TOWN OF FORT MILL PLANNING COMMISSION MEETING

May 17, 2016
112 Confederate Street
6:00 PM

AGENDA

**Planning Commission Meeting
May 17, 2016
Items for Information / Discussion**

May 2016 (Current) Version

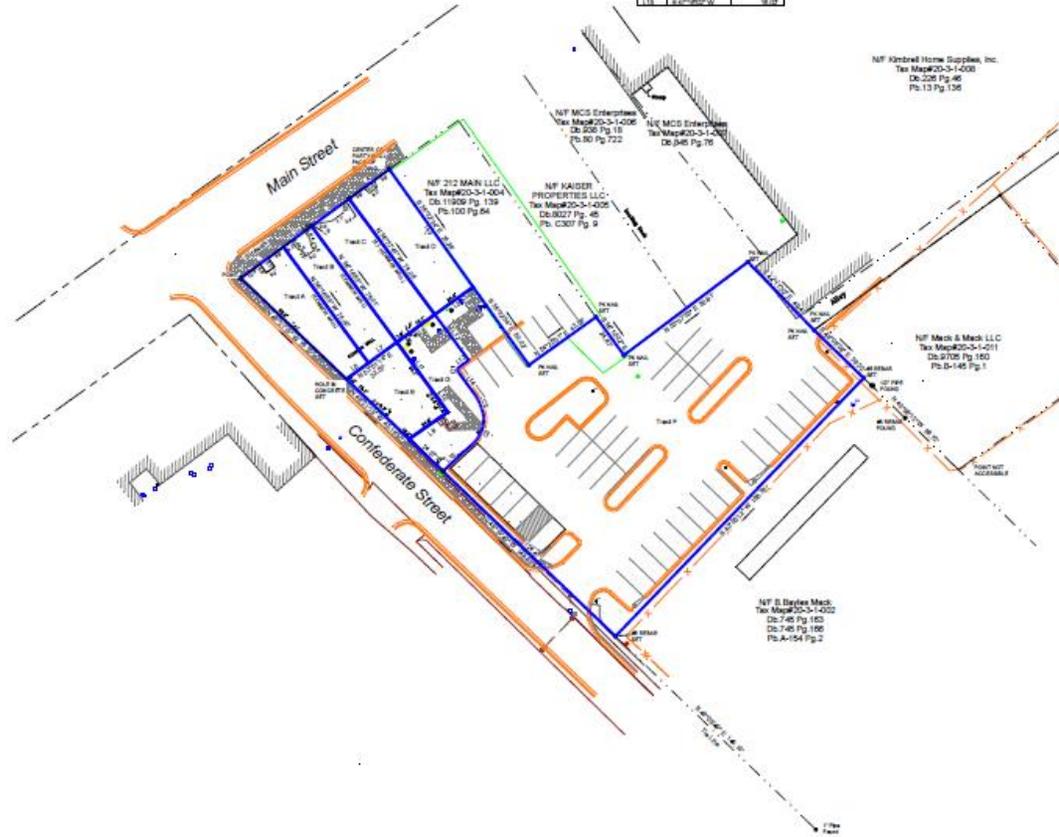
Based on the LC district regulations, the proposed parcels A, C, D, F and G will conform with the minimum requirements of the zoning ordinance. At 1,371.89 and 1,278.33 square feet respectively,

Parcels B and E will be smaller than the minimum lot size requirement of 1,500 square feet. Parcel B will also have a slightly smaller lot width along Main Street (17') than the 20' minimum required by the zoning ordinance.

Because the proposed property lines will follow shared common walls between several historic buildings, it is staff's opinion that an unusual condition exists in this situation, and that strict application of the minimum lot area and width requirements would create a hardship for current and future property owners. For example, strict application of the minimum lot width requirement would necessitate a property line being drawn down the middle of an existing building, rather than the common wall. Staff, therefore, recommends in favor of approval.

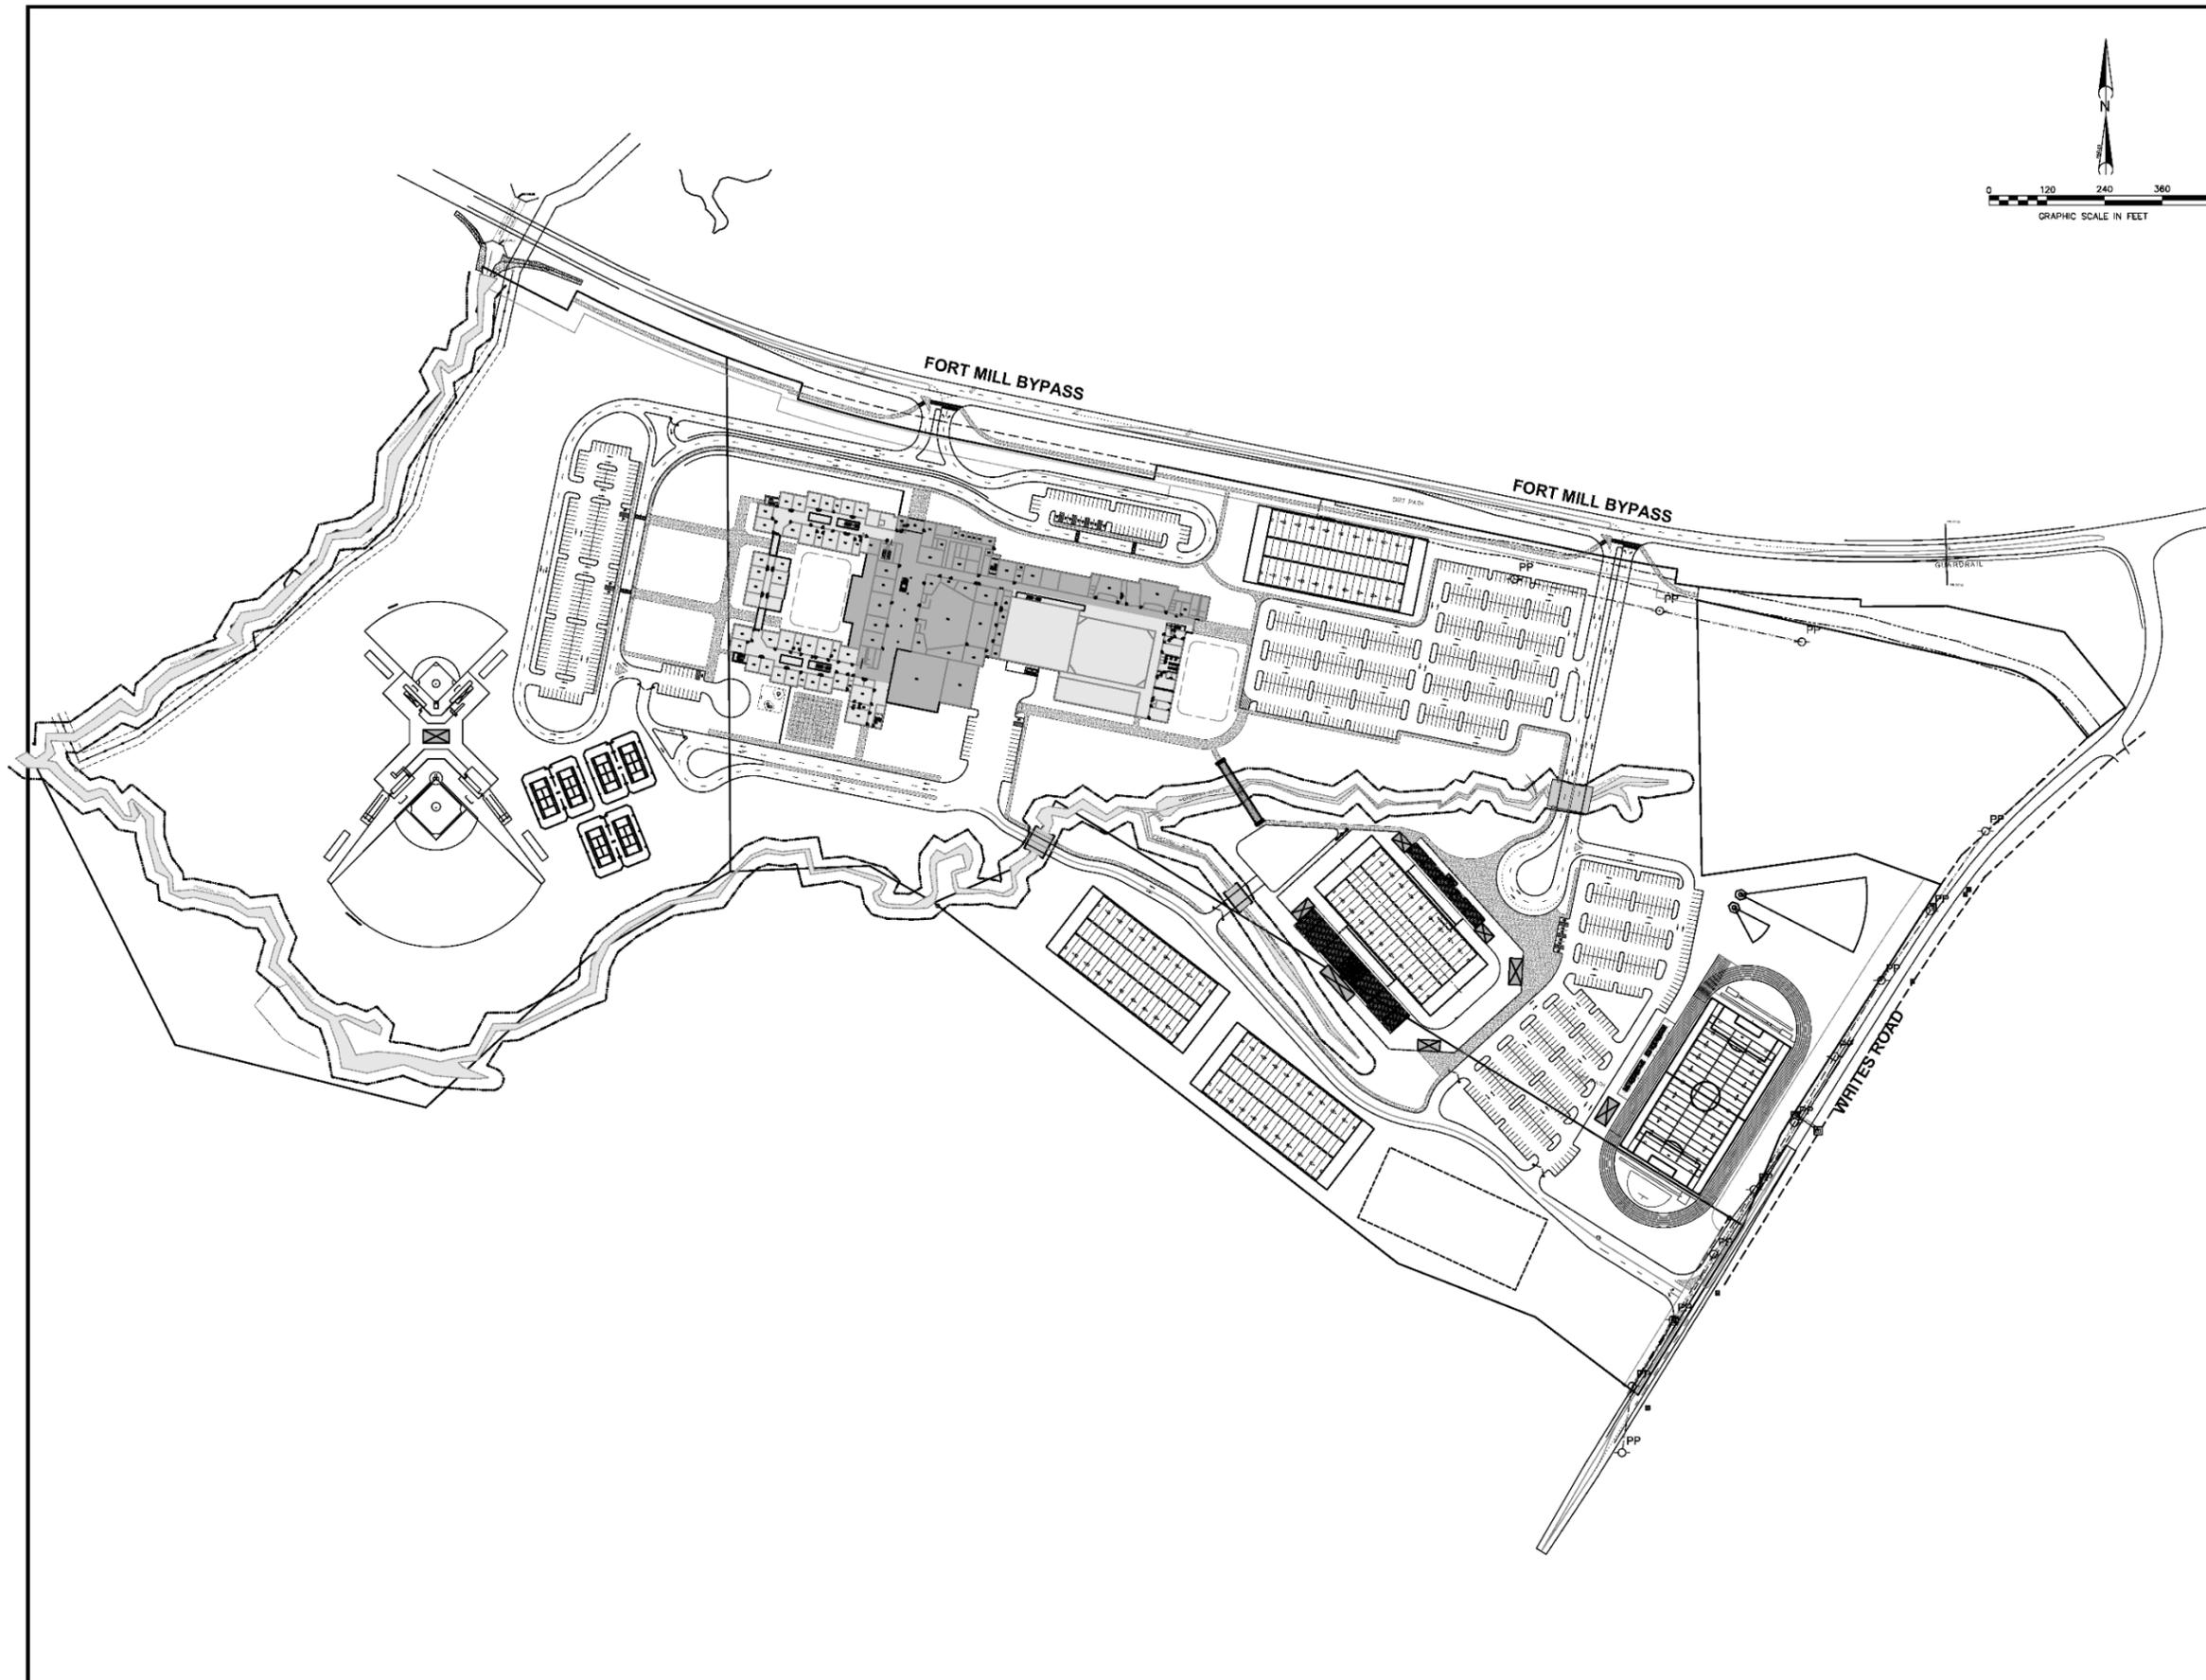
The proposed building and associated improvements meet the setback requirements of the COD and COD-N overlay. The building height requirements for the COD-N overlay district, which will cover the majority of the buildings, is listed as a 20' minimum and 45' maximum height. The proposed building design appears to meet the 20' minimum building height requirement (need architect verification), however it also exceeds the 45' maximum height. The Planning Commission, at their discretion, could approve any deviation using the procedure noted in Subsection 17 "Alternative means of compliance" within the COD-N overlay code. If the Planning Commission does not approve the deviation, the applicant would need to submit a request for variance to the Board of Zoning Appeals. The applicant has noted that significant grade changes and creek/stream buffers limits the buildable area, which is why portions may exceed the 45' maximum height.

The Planning Commission shall have the discretion to determine if the proposed plan meets the requirements, and intent, of the COD-N overlay district requirements. Staff will note that pedestrian access from the street is encouraged and the current plan does not show internal sidewalks connecting to the sidewalks on the corridor.

Parking, as shown on the attached site plan, exceeds the requirements of the zoning ordinance. As mentioned previously, the parking is to be located to the side or rear of the structure(s) to the extent practical. The Planning Commission, at their discretion, shall determine whether the proposed design meets the requirements, and intent, of the COD-N overlay district.

A key to the overlay requirements is to create a pedestrian/bicycle friendly environment. As such, the overlay requires that bicycle parking be present in addition to vehicular parking. Bicycle parking shall be provided at a rate equal to 5% of the required vehicle parking (0.0175 per student). Bicycle Parking is not shown on the provided plans.

Parking lots are to have landscaped medians every 25 spaces. The provided plan set appears to meet this requirement.
